# Design For Manufacturing

2026.09.04

| Part Name              | 1/4" x 7/16 UNS TAP ADAPTOR BODY                      |
| Part No.               | CPP-45JU7F-01                                         |

# Draft Analysis

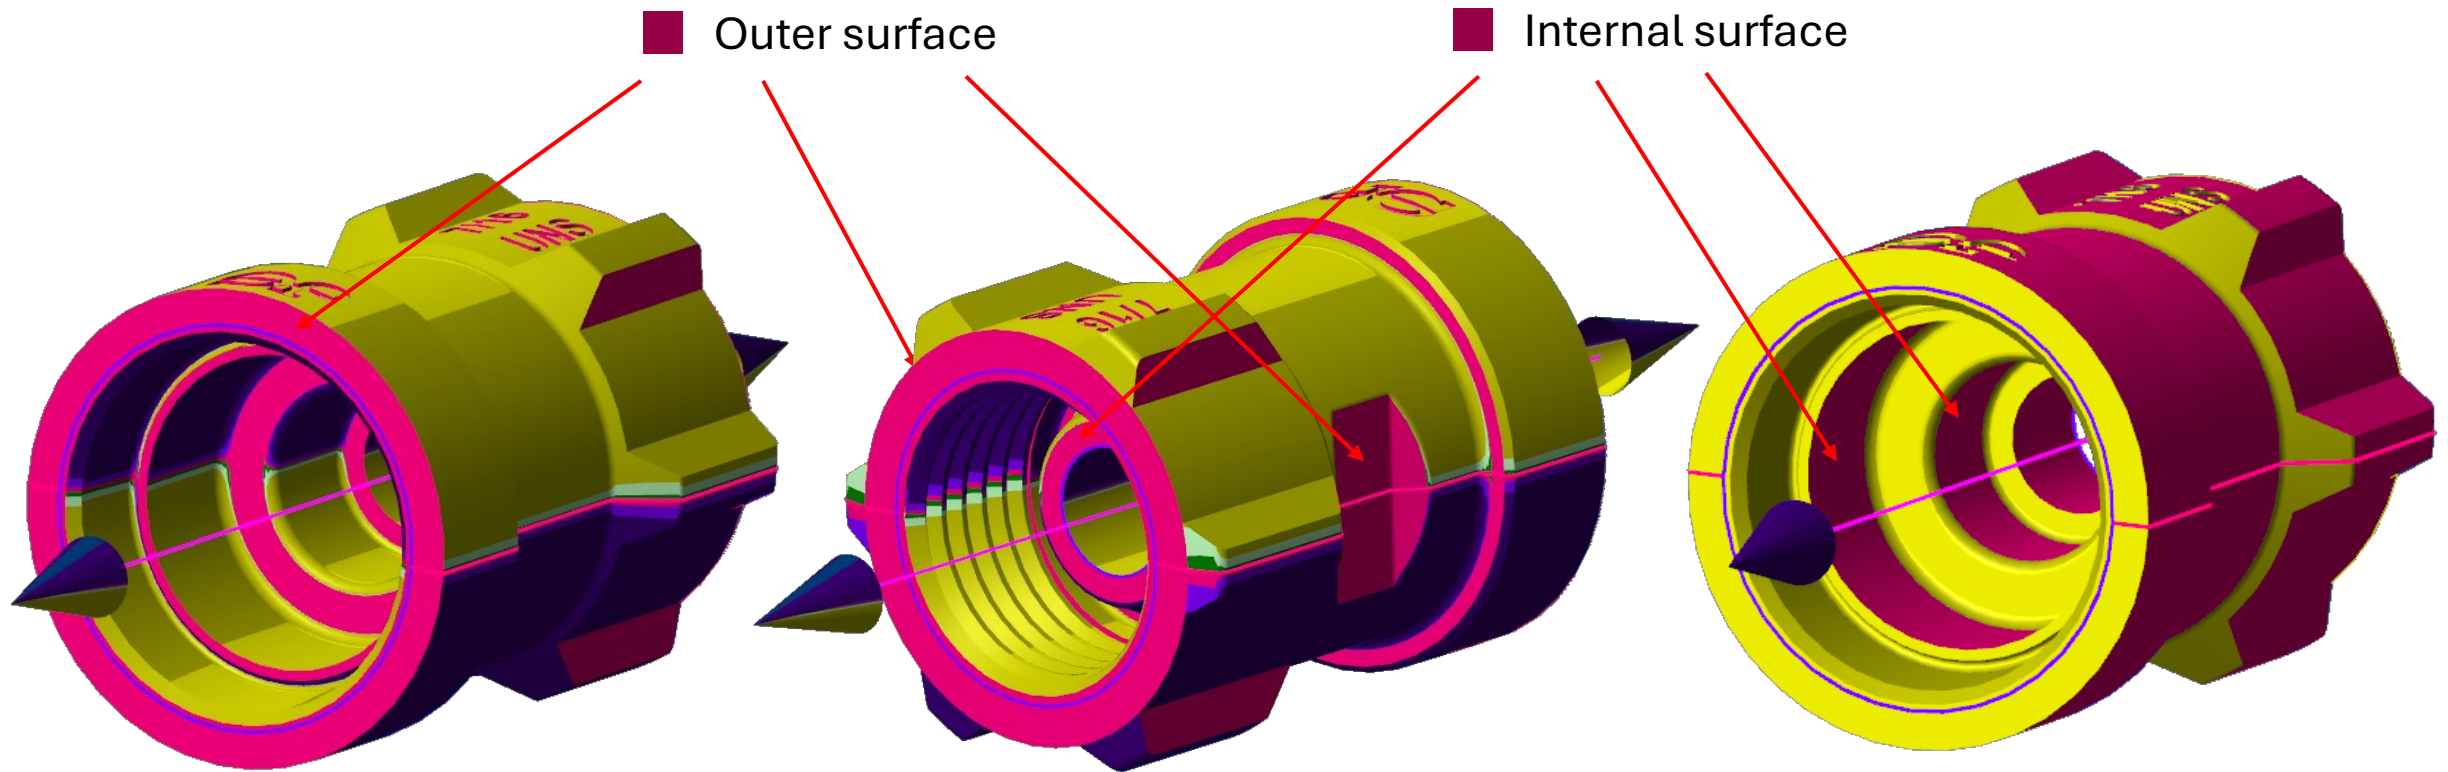
The red surfaces shows no draft angle for model. We suggest adding a **1° draft** to avoid drag marks during ejection. Please review and confirm your approval.

# Gate location

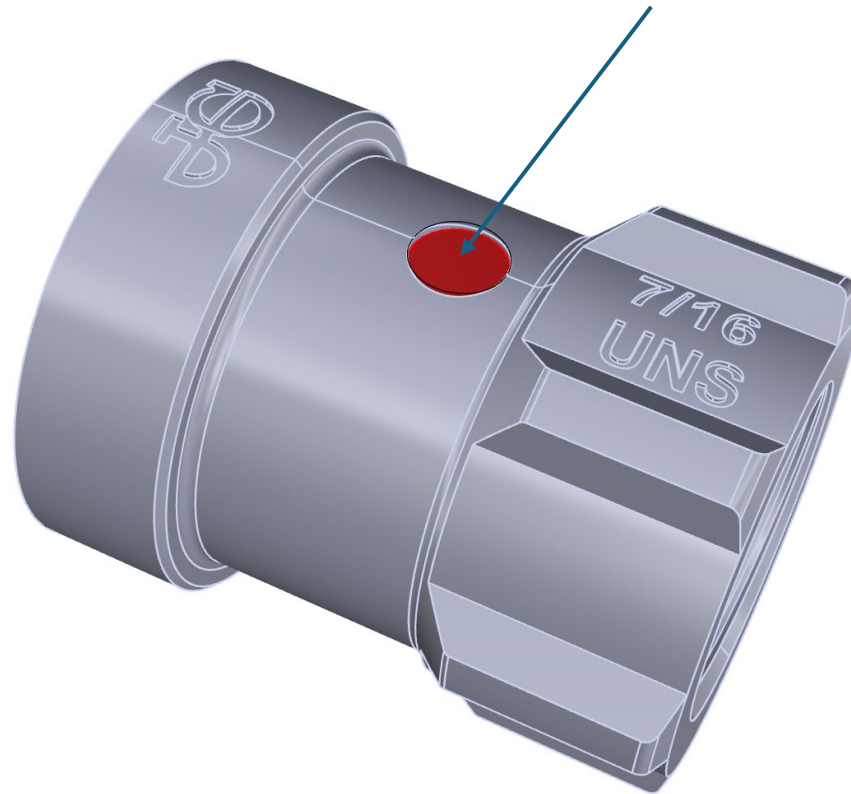
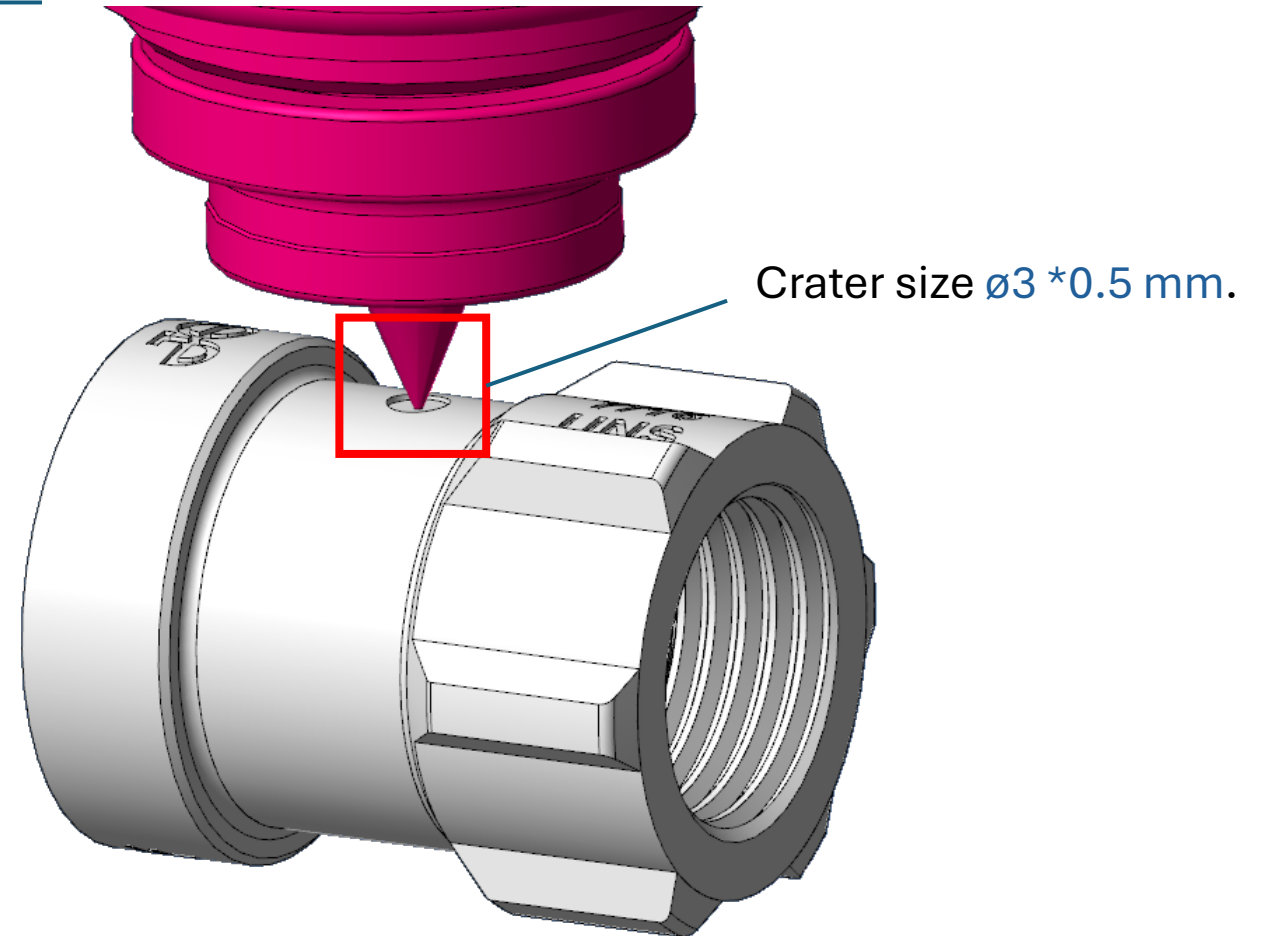
Gate location and crater size is around  $\varnothing 3 * 0.5$  mm

We plan to set the gate location at the red dot area and add a 0.5 mm deep crater.  
Please review and confirm if this is acceptable.

# Ejector pin location

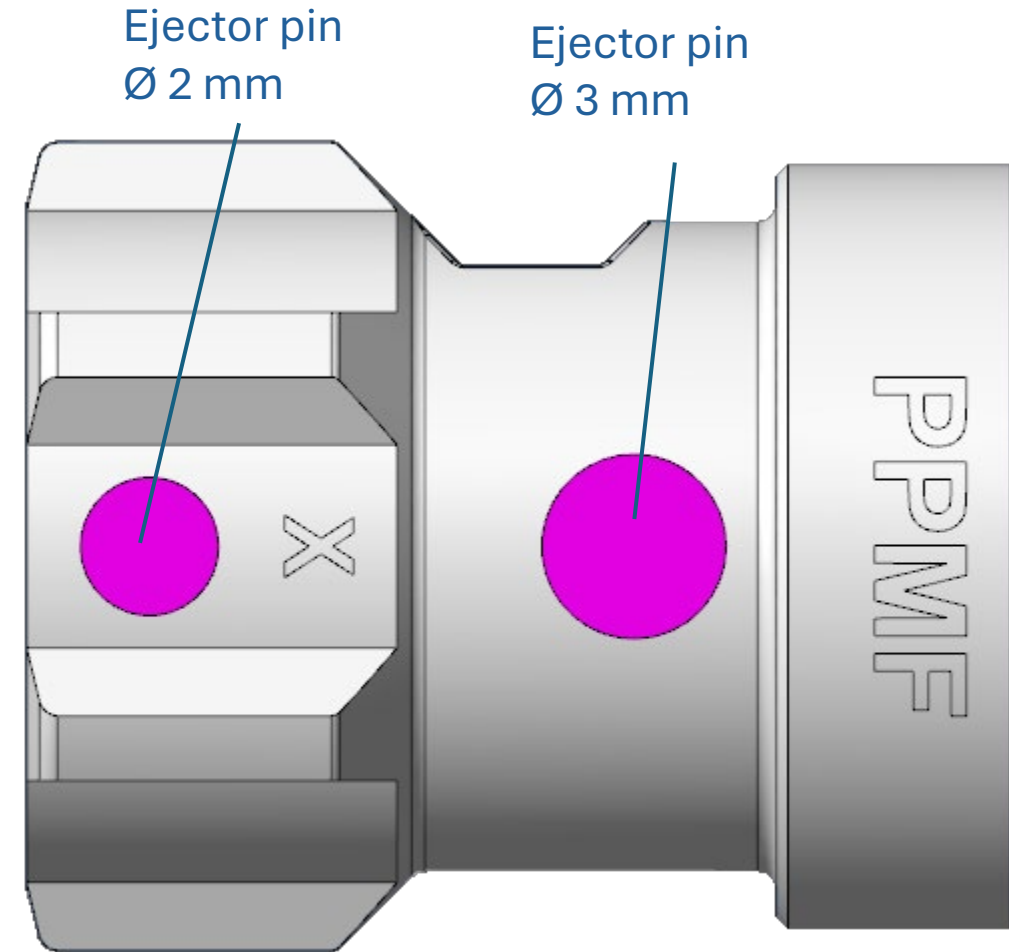
We plan to locate the two ejector pins as shown in the picture.  
Please review and confirm if this is acceptable.
